MSEX3032A-01

S E R V I C E N O T E

MSEX3032A – Oscilloscope, Mixed Signal, 2+8 Channel,
350MHz

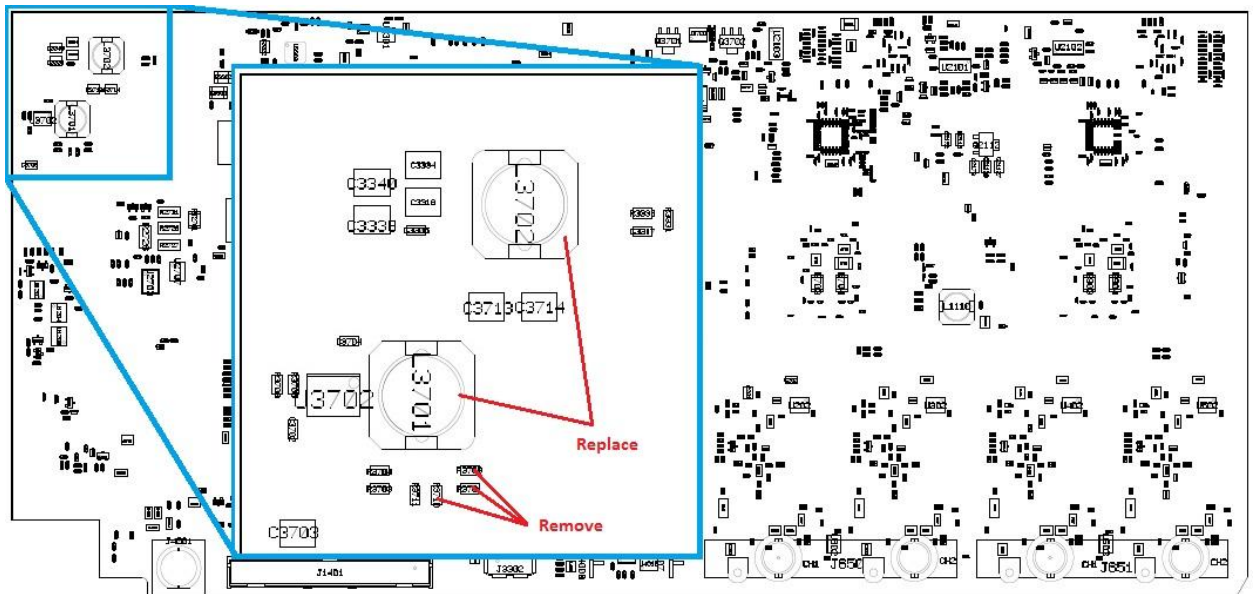
With the oscilloscope power turned on and while under normal operation, the unit emits a hissing noise.

2. As the picture indicates, remove the three resistors (0699-7209, 1 Ohm) located at R3701, R3709, and R3710. They are not to be replaced.
3. Remove as well the two inductors (9140-6474, 100uH) located at L3701 and L3702 and replace them with inductors with part number 9140-6151 (68 uH).
4. Re-assemble to the point where the unit could be powered up to verify that the hissing is indeed gone. If the hissing is not gone, please, check modifications.
5. When the hissing is gone, put oscilloscope back together.
